AppSer. No. 09/854,304.

AUTO-ADJUST NOISE CANCELING MICROPHONE WITH
POSITION SENSOR

Reply to Office Action of July 9, 2004
Annotated Sheet Showing Changes.

FIG. 1

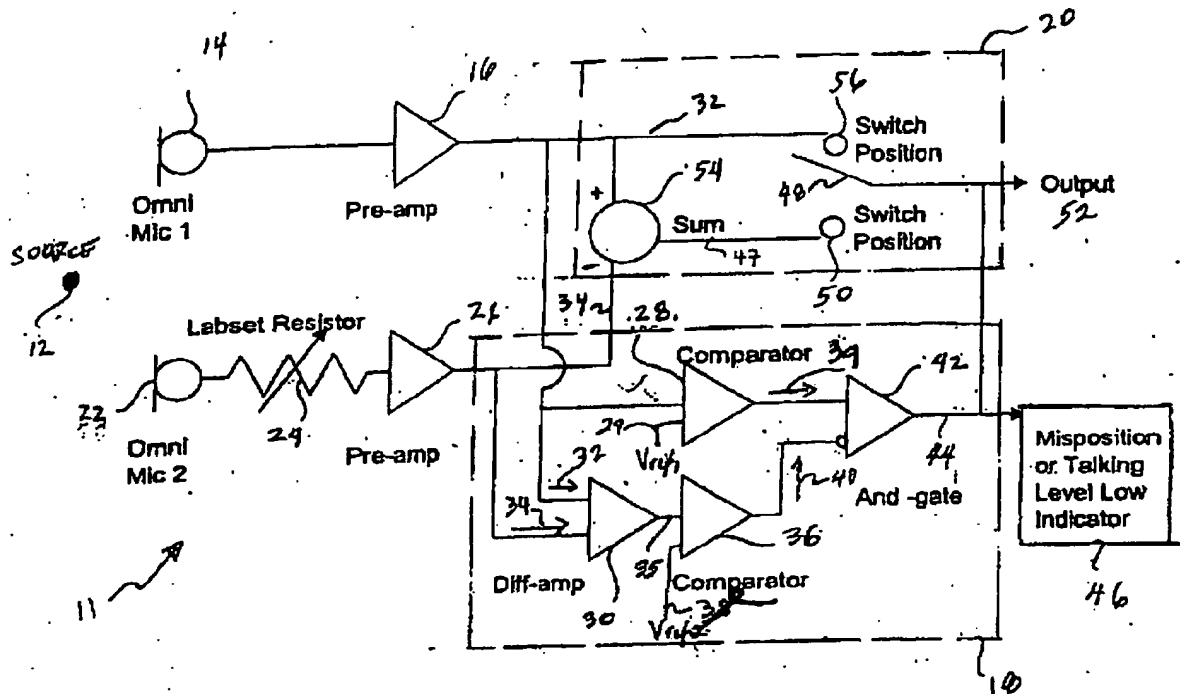
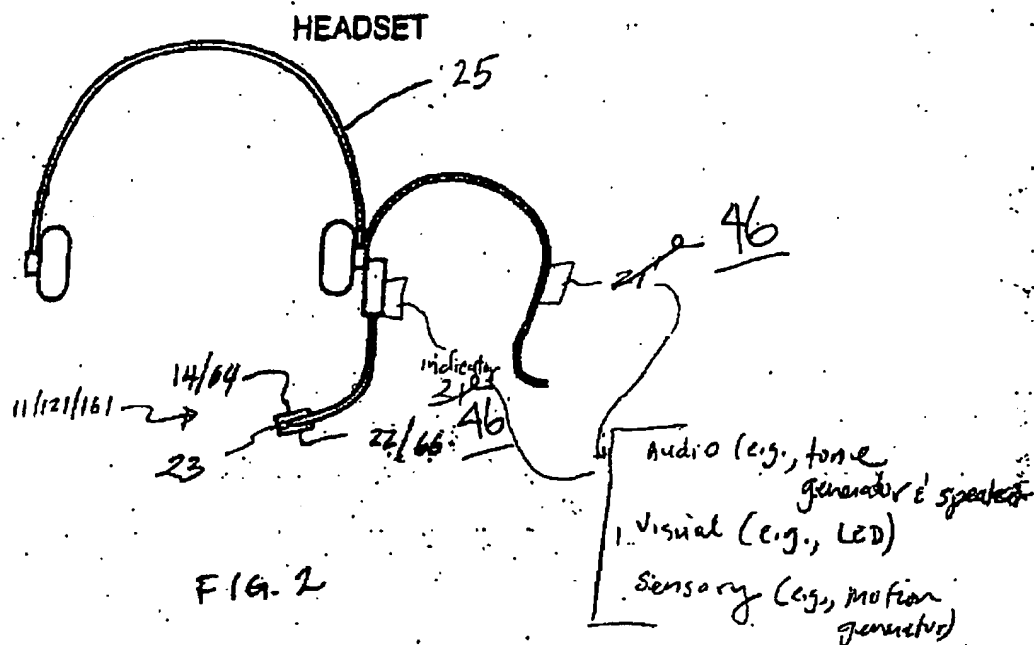
Some minor errors are also corrected in FIGS. 1-3. In particular, in FIG. 1, reference number 38 is removed as the specification does not contain reference to 38.

FIG. 3

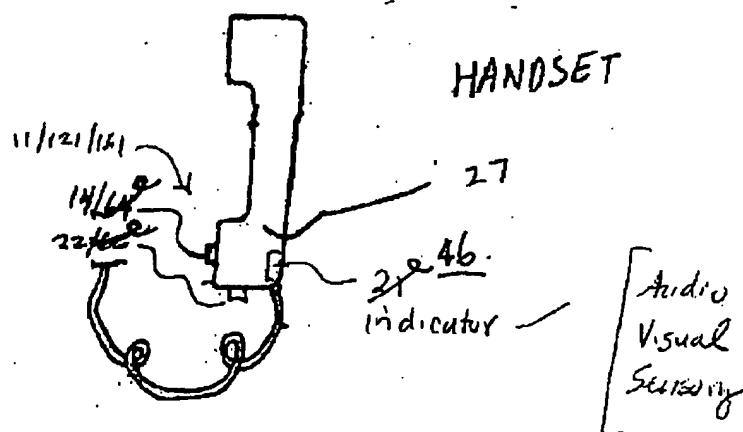
In both FIGS. 2 and 3, reference numbers 64 and 66 are removed as the specification does not contain reference to 21, 64, or 66. In addition, in both FIGS. 2 and 3, each instance of reference number 21 is corrected with reference number 46.
